BENDOLPH ESTATES SUBDIVISION

APPLICATION NUMBER 3 DATE January 6, 2011

REQUEST Subdivision

DETAIL SITE PLAN

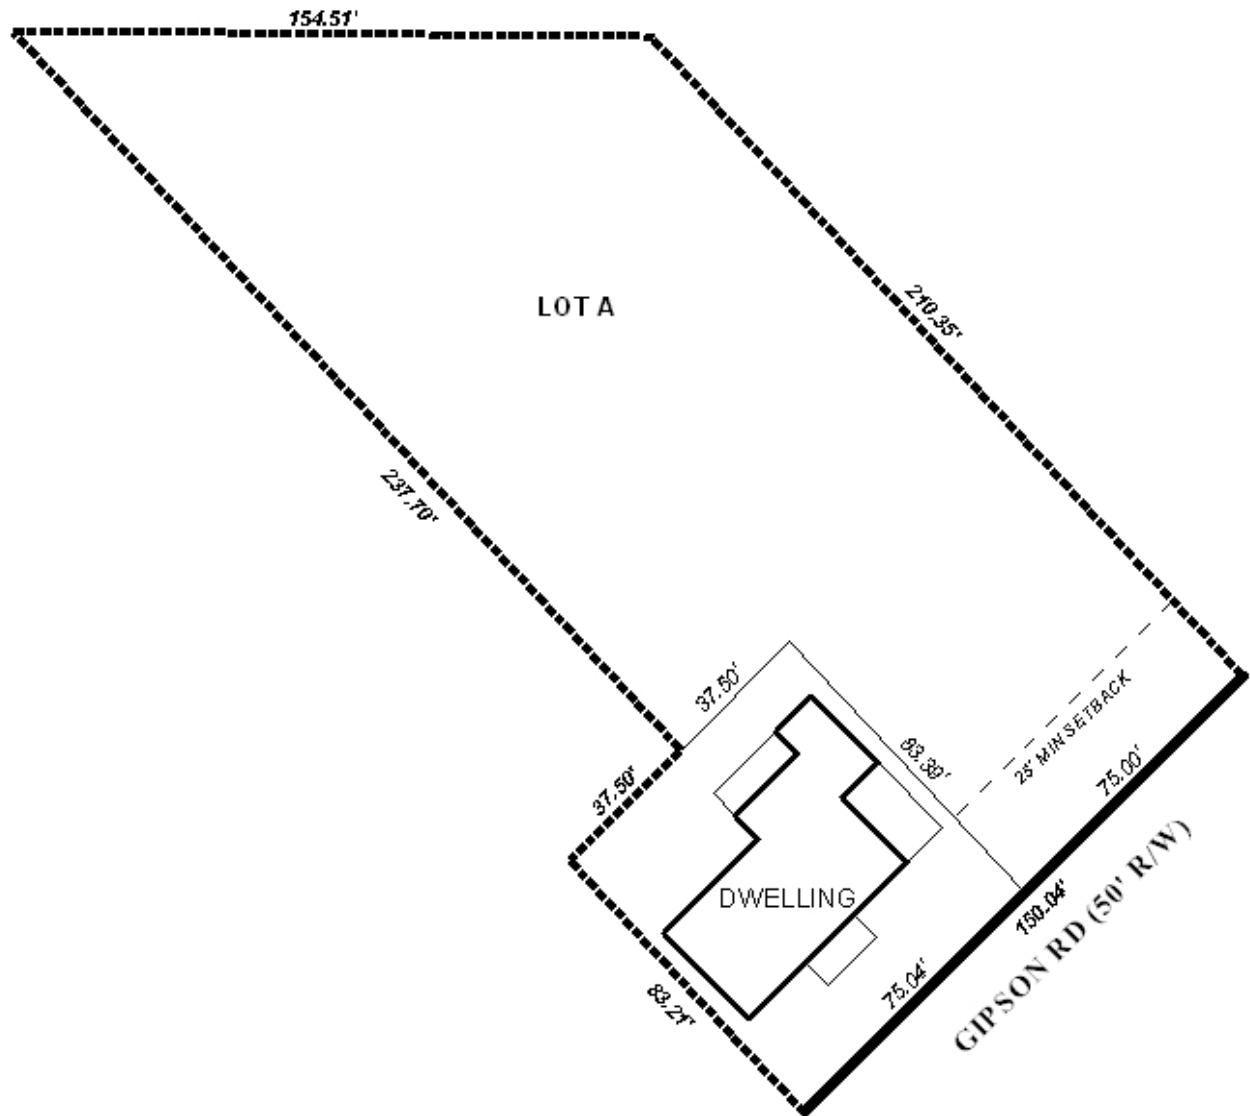
The purpose of this application is to create a one lot subdivision from a legal lot of record and a metes and bounds parcel. Lot size is not given, and should be included on the Final Plat if approved.

The 25-foot minimum building setback line, required in Section V.D.9., is illustrated on the preliminary plat, and should be retained on the Final Plat, if approved.

- 1) depiction of the 25-foot minimum building setback line;
- 2) the labeling of each lot with its size in square feet, or placement of a table on the plat with the same information;
- 3) compliance with Engineering comments (*Must comply with all storm water and flood control ordinances. Any increase in impervious area in excess of 4,000 square feet will require detention. Any work performed in the right of way will require a right of way permit.*)
- 4) approval of all applicable federal, state and local agencies prior to the issuance of any permits or land disturbance activities;

- 5) placement of a note on the Final Plat limiting the development to one curb cut each to Gipson Road, with the size, design, and location of all curb cuts to be approved by Mobile County Engineering and conform to AASHTO standards;
- 6) placement of a note on the Final Plat stating that approval of all applicable Federal, state and local agencies is required for endangered, threatened or otherwise protected species, if any, prior to the issuance of any permits or land disturbance activities; and
- 7) full compliance with all other municipal codes and ordinances.
